Meeting: Traffic Management Meeting
Date: 15 February 2017
Subject: High Street, Silsoe - Consider the implementation of waiting restrictions, raised features and speed limit changes in Silsoe

Report of: Paul Mason, Head of Highways

Summary: This report seeks the approval of the Executive Member for Community Services for the implementation of waiting restrictions, raised features and speed limit changes in Silsoe.

Appendix A - Waiting restrictions

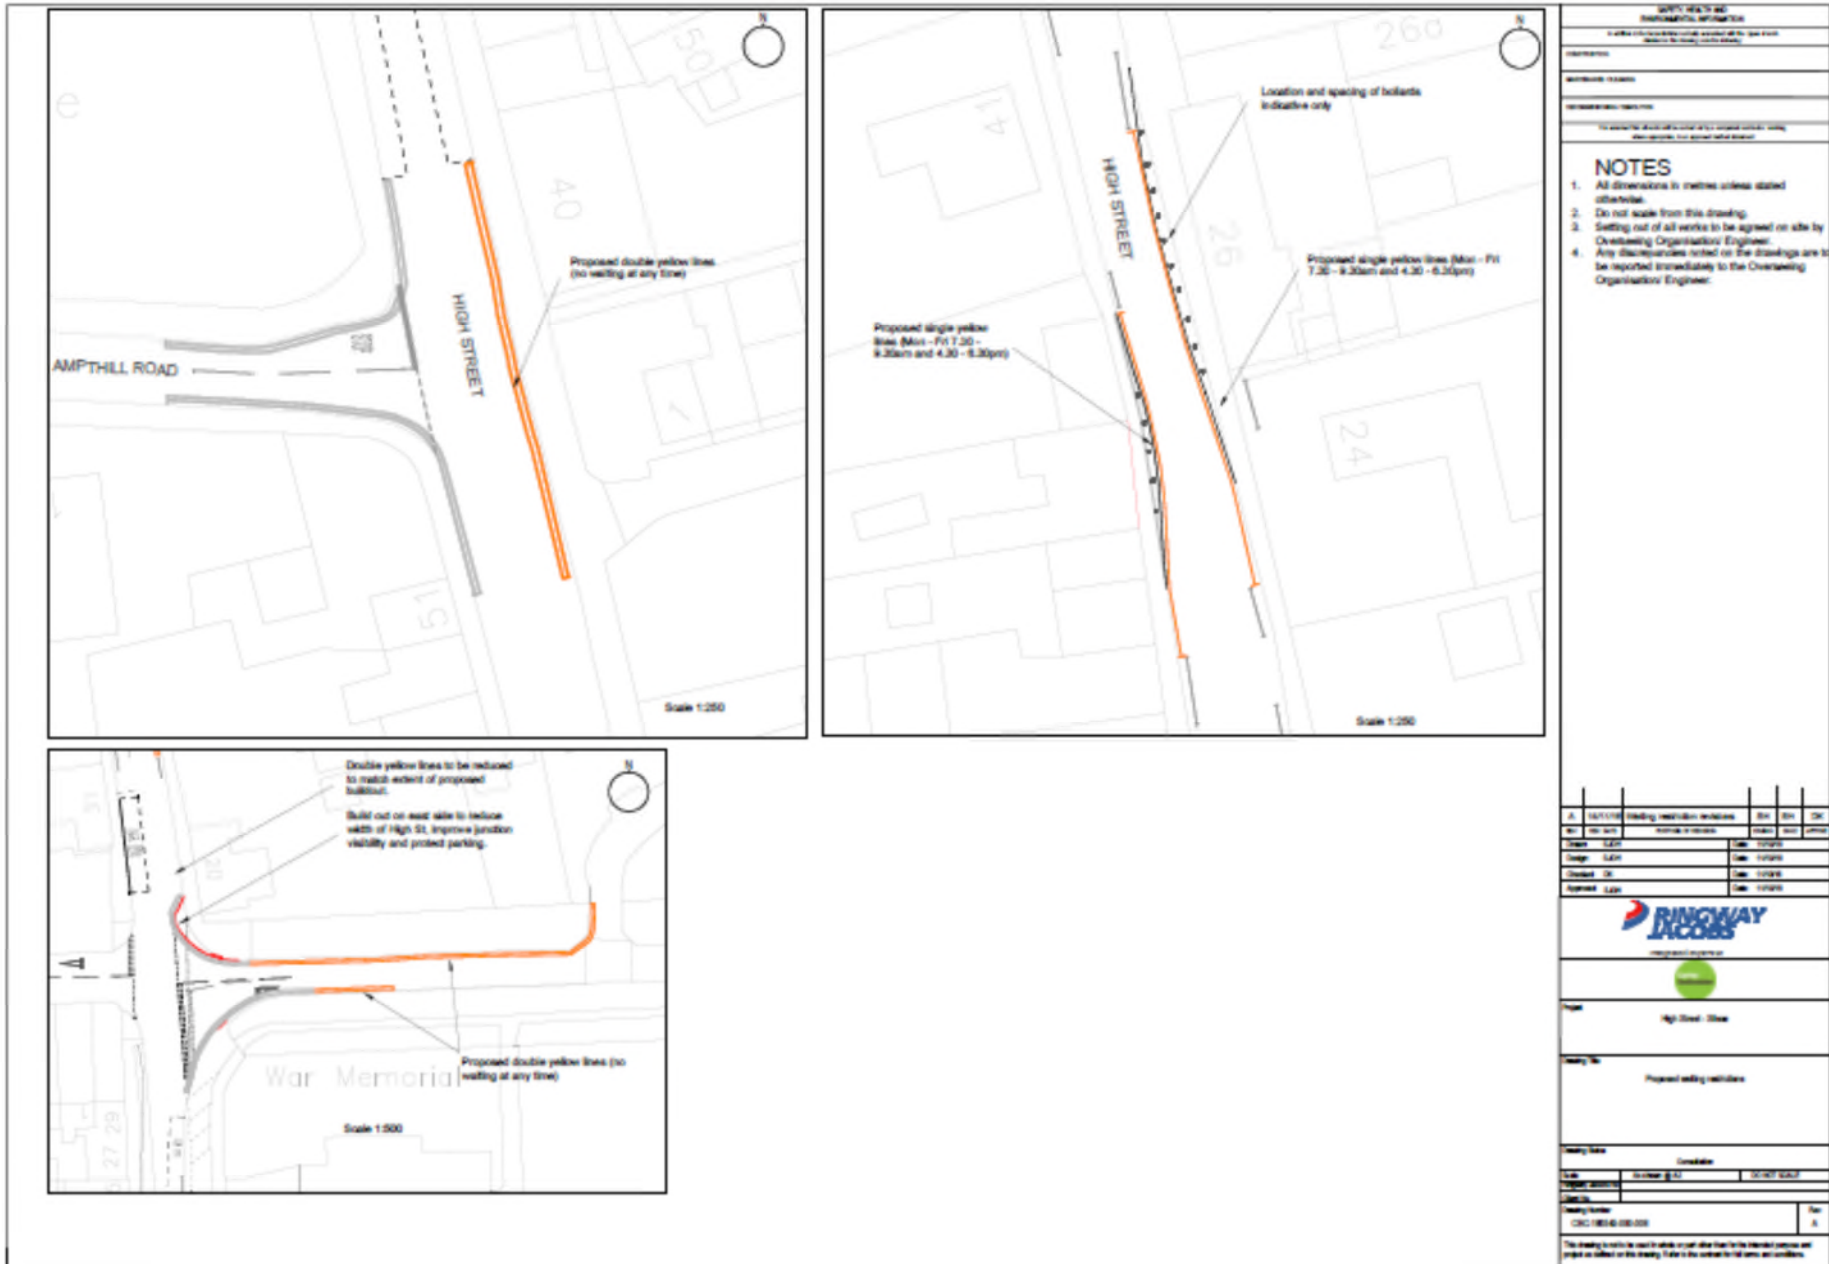
- installing some speed bumps to slow the cars down or installing a pavement or path for pedestrian usage would surely be the best solution
11. Objection to waiting restrictions near the shop

- Loss of trade
 - Parked cars naturally calm traffic
 - Vehicle speeds will increase
 - Yellow lines are visually intrusive

- Extend the double yellow lines in the central area on the High Street to guard against poor parking
- Extend the parking restrictions on the south side of Park Avenue

The single yellow lines have been chosen to be taken forward as means of dealing with the congestion in the village centre which was a source of much concern for the parish council and local residents.

In order to strike a balance of keeping traffic moving and not restricting trade for the village shop that single yellow lines were the best solution. In the resident survey this was also the most favourable solution from respondents.

By restricting parking at the peak-hour times only would enable traffic to flow at a suitable speed. The volume of two-way traffic and the physical environment at these times will encourage drivers to negotiate the centre of the village at low speeds. At times when there is a reduced flow in each direction, vehicles would be able to park in this area. This would act as informal traffic calming when the bi-directional balance of traffic is reduced.

We are aware of the conservation area in Silsoe and therefore have planned to implement any lining in the conservation area in the colour of primrose.

The scheme has been designed to try and keep parking restrictions to a minimum in order to aid the low speed flow of traffic at peak times without impeding the trade of the local shop. It is unusual that drivers park over vehicular entrances to the highway. To help facilitate access and egress we note these concerns and will look to add H-bar markings to help prevent access issues.

On Park Avenue the scheme has proposes to install the proposed double yellow lines to enable access and maintain visual splays for pedestrians and drivers. The proposal recognises some need for parking and has allowed for some parking away from the junction. Utilising informal parking in this way will help to reduce the speed of vehicles exiting Wrest Park and approaching the centre of the village where there is likely to be higher levels of activity and vulnerable road users.

Appendix A - 20mph speed limit

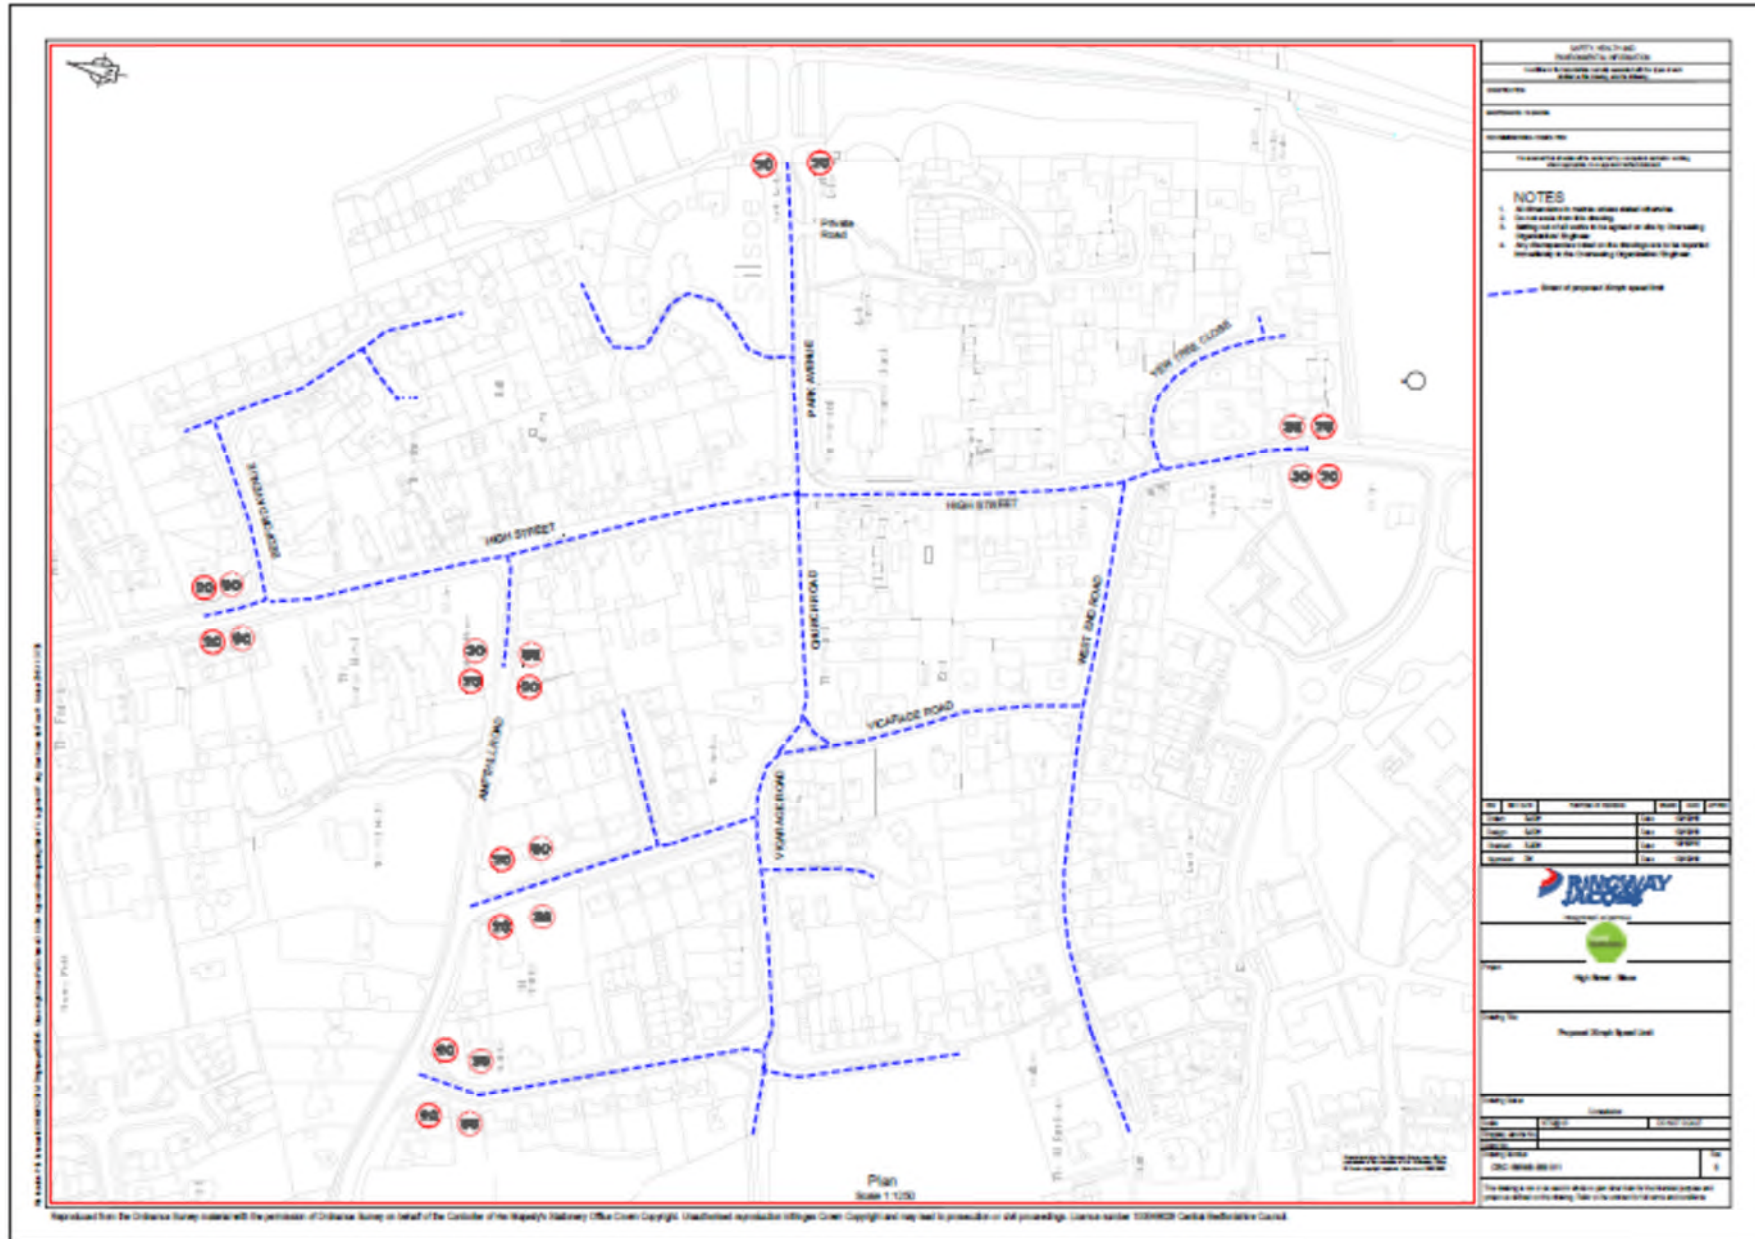
- Agreement with the speed limits being applied for in Silsoe but was wondering whether Ampthill Road and Newbury Lane could be included?
 - The proposal would be greatly improved by starting the 20mph limit on Ampthill Road before Fir Tree Road.

- All of Ampthill Road should be included in the 20mph speed limit
10. Additional raised tables – (Park Avenue and Ampthill Road)
 - Consideration of raised tables along Ampthill Road to slow the traffic as most drivers take no notice of existing village speed limits.

It can be seen that there may be benefits to extending the 20mph speed limits to other areas. However, in order to extend the 20mph speed limit along Ampthill Road then there would be a need for a significant amount of additional traffic calming measures in order to comply with DfT guidance and legislation. This would be outside the scope and budget of this S106 funded scheme.

Church Road/Park Avenue Junction

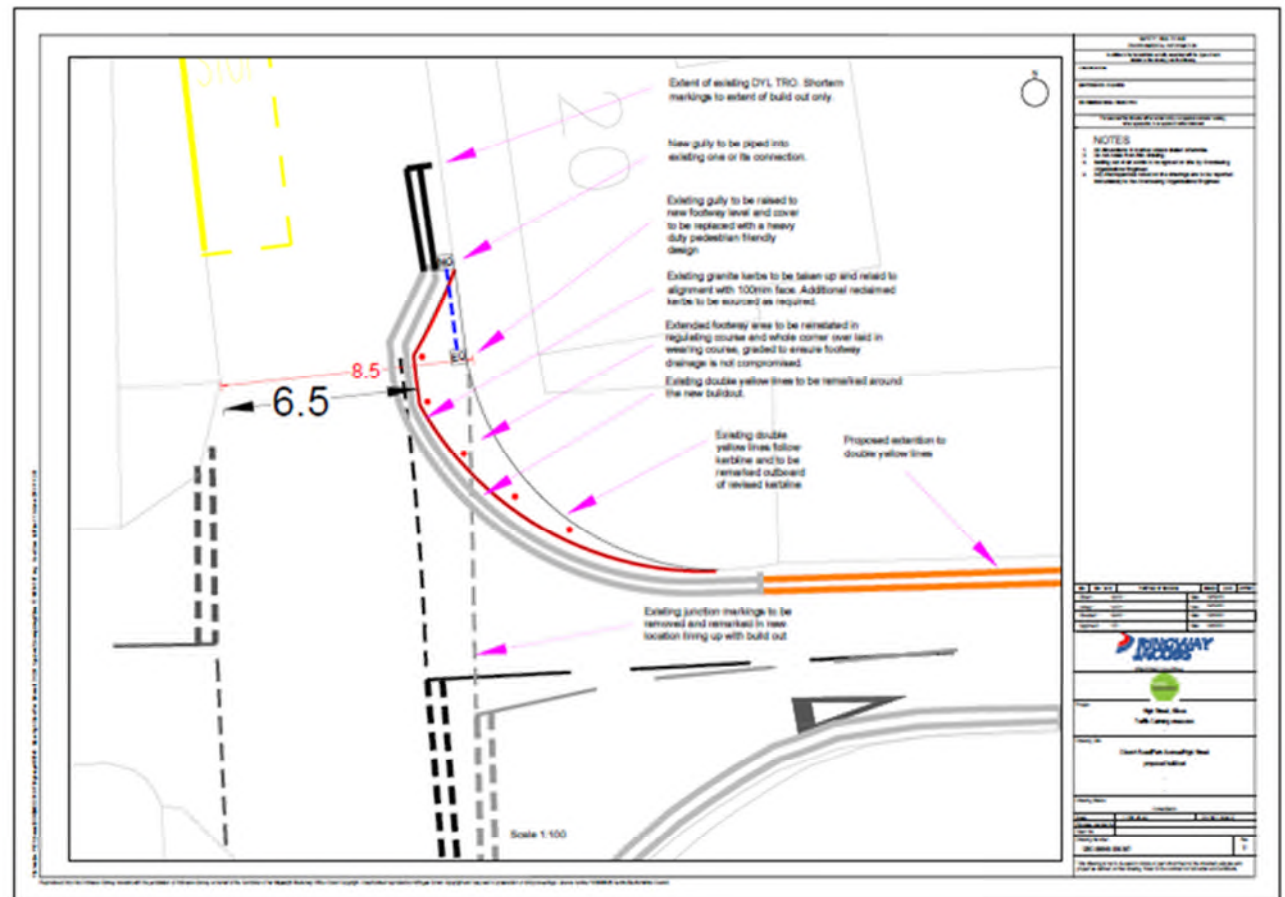
Is anything being considered to remedy the problems that these cottages are suffering from? It is wrong, and somewhat ironic, that a conservation area is being subject to such a volume of traffic. While our house, 20 High Street, has experienced no problems of that nature thus far, this may change with the size and increasing number of large vehicles using Park Avenue past the south side of our house, as well as those who ignore the sign to turn left but turn right, passing the west face of our house. Why can the High Street from Park Avenue northwards not be a lorry ban area as in Maulden Road, Flitwick where the lorries turning out of the industrial estates must turn left? An even better solution would be to have a weight restriction on vehicles accessing Wrest Park. With this comment in mind about the deterioration of the cottages in mind, we would like assurances that the proposed works will have no impact on the structure of our house or any damage to it while the work is being carried out, or indeed afterwards. We would also like an assurance that if the house, which was repainted this year, is soiled during the work, it will be put back to its current state.

A number of measures were considered for this area. A number of these had to be discounted due to the proximity of listed buildings that are reported to have structural movement issues. It is highly likely that adding a raised table here would exacerbate these issues for these properties.
